DATE: February 15, 2023
TO: Ty Lasher, City Manager
FROM: Anne Stephens, Public Works Director
RE: Woodlawn Project – Proposed Change Order #11 - Odessa Retaining Wall Change Order

Re: KDOT Project 87 N-0678-01
Bel-Aire / Woodlawn, 37th St. N. to 45th St. N.
Landscape Retaining Wall Change Order Request

WOODLAWN - 37TH ST. N. TO 45TH ST. N.

1388 DRY-STACK STONE RETAINING WALL 1- PLAN & PROFILE

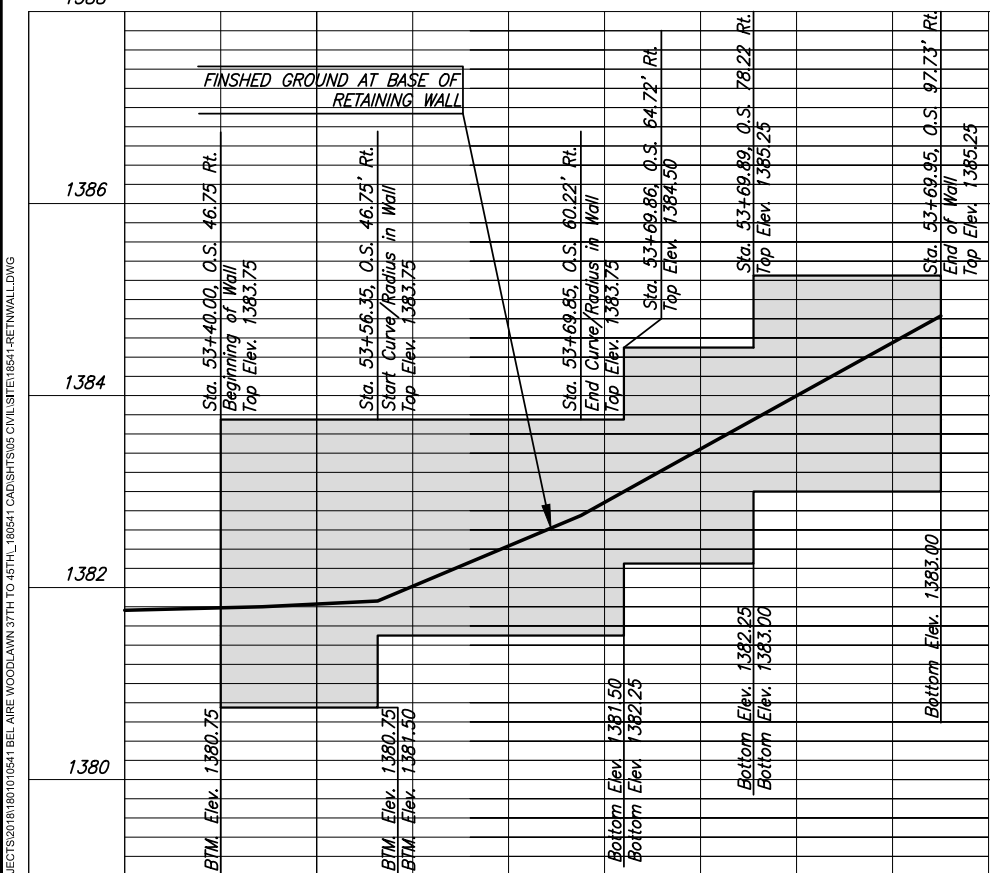
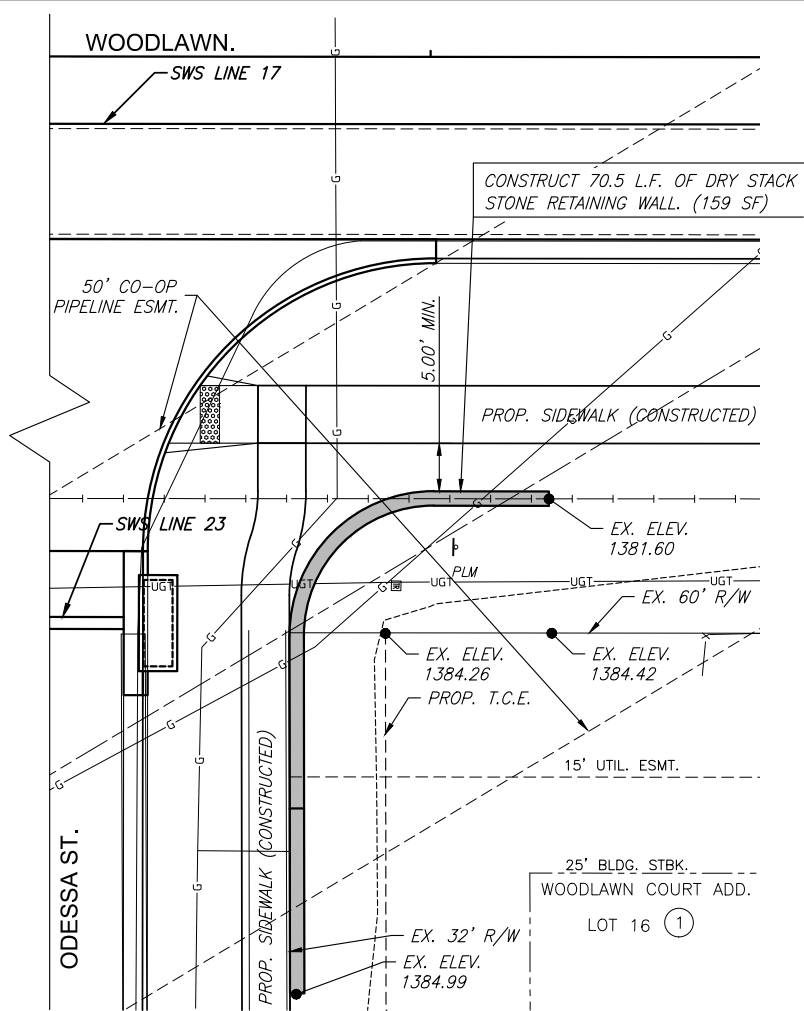
With the sidewalk and street being installed on Odessa, it was noticed that there is a need for retaining walls at the north and south edges of the intersection with Odessa and Woodlawn.

There are two issues necessitating these walls. First – there was not enough temporary construction easement acquired to allow for a smoothly graded transition between the new sidewalk and the existing ground. Secondly, even if enough temporary construction easement had been acquired, the root system of the large existing tree to the south would have been damaged to the point of necessitating removal of the tree and the flagpole monument located on the north property would have needed relocating/reconstruction to allow for the grading. In light of these issues, it was determined by the project team that the best current course of action to remedy the situation is to install a small retaining wall on these two corners. Pearson is not requesting any additional days through this change order.

Due to the steep grades at the Woodlawn & Odessa Intersection, it was determined that a Landscape Retaining Wall would be required for the project. Pearson Construction requests \$38,556.00 for this work.

Attached are retaining wall plans, profiles and details for what we are thinking on Woodlawn. The extent of wall shown is less than what we discussed possibly on site. We reviewed the need for wall along Perryton and Woodlawn Ct. and determined grading should suffice at these locations. Please note the quantity of wall at the bottom right of the plan and detail sheet. The style of stone was reviewed by our landscape folks and the City. If you have questions or suggestions, please let us know.
